SHORES AT PALMETTO BAY, LLC

VPB-11-001

From: Gavilan, Ricardo (PWWM) <rlg@miamidade.gov>
Sent: Thursday, November 17, 2011 5:29 PM
To: ajpalumbohome@gmail.com; Rolando Llanes
Subject: FW: Palmetto Bay Charter School (K-12), SW 97 Avenue & SW 178 Street Recommendations
Attachments: 100207_A2 (Rev 03).pdf; 100207_PKPB_TOP (Rev 2).pdf

SUBJECT: Palmetto Bay Charter School (K-12) - Traffic Impact Study Review

SITE PLAN

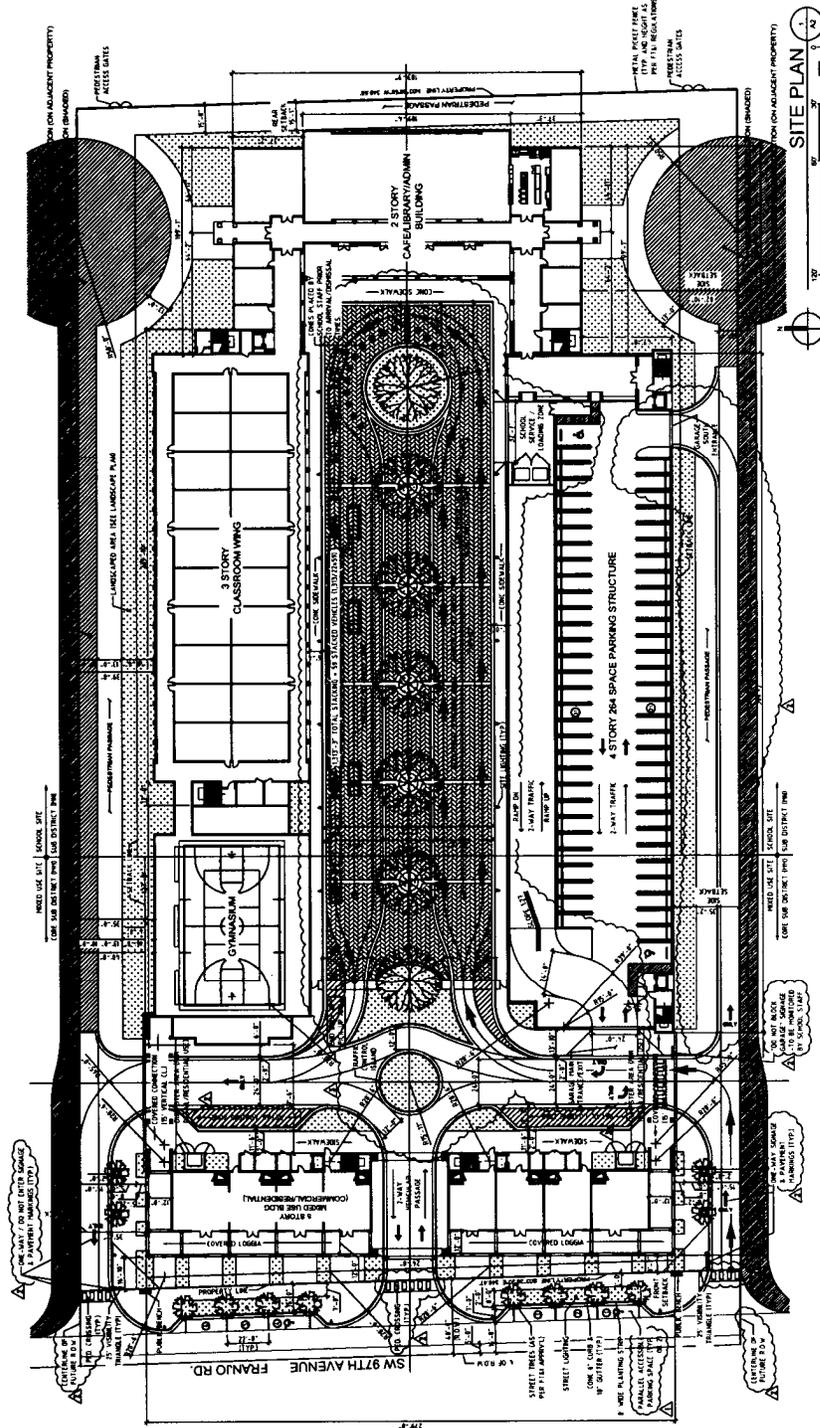
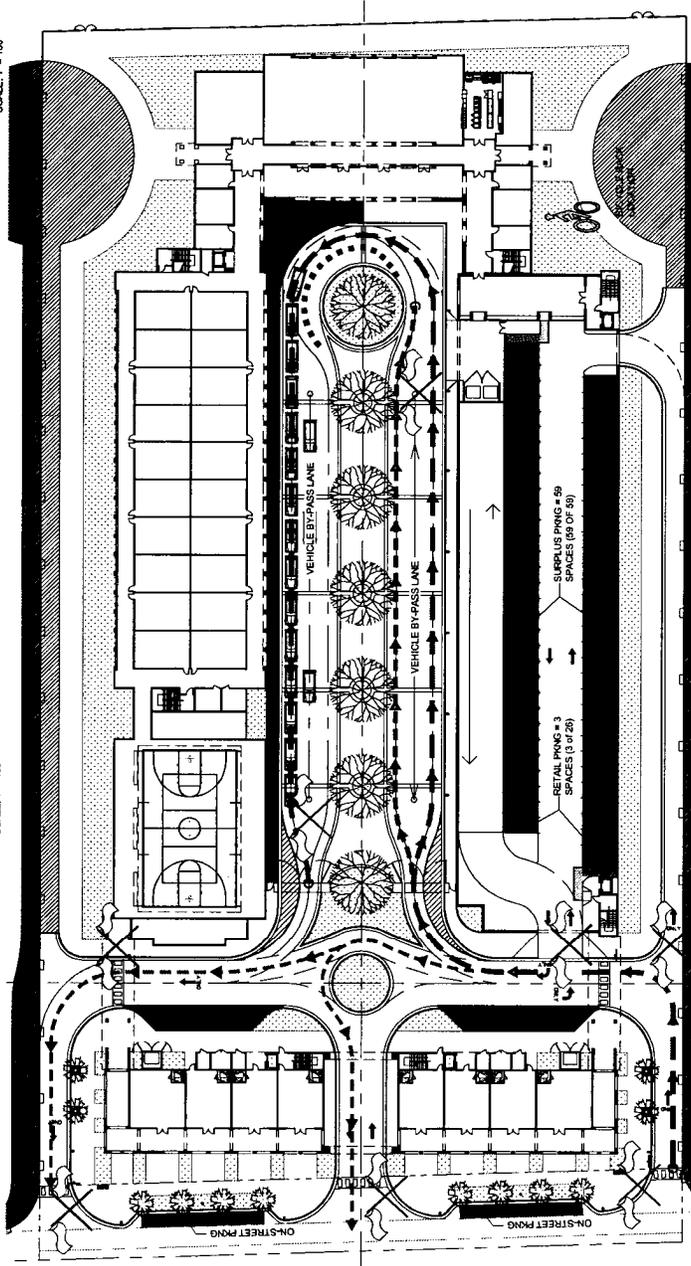
1. The FDOT intersection sight distance triangle must be shown at exit driveways. On-street parking space must not obstruct sight distance for exiting vehicles.
2. A two lane exit driveway onto SW 97 Avenue, located on the NW corner of the site, must be proposed in site plan as supported by the Traffic Impact Study analysis. It is recommended that the pavement width of 20 feet be proposed to accommodate a right turn and left turn lane.

3. The misalignment of the central two-way vehicular driveway with the school's entrance and exit driveways creates poor traffic delineation. Solutions to better delineate traffic movements (i.e. roundabout, traffic channelization islands, ect.) must be provided.

4. Pedestrian crosswalks shall be provided at all natural street crossing points (i.e. under covered loggia, across continuing sidewalks, ect.). Ensure all crossings have adequate pedestrian site distance.

5. The proposed side street widths and centerline should align with required future dedications.
6. An "Auto-Turn" illustration for a standard SUV vehicle navigating the inside "by-pass" lane within the "u-turn" driveway shall be shown on the site plan.

7. Designated one-way traffic roads and driveways shall be clearly indicated on site plan with proposed signage and pavement markings.
8. Vehicle turn around areas must be proposed where dead-end aisles occur (i.e. fourth floor parking garage).
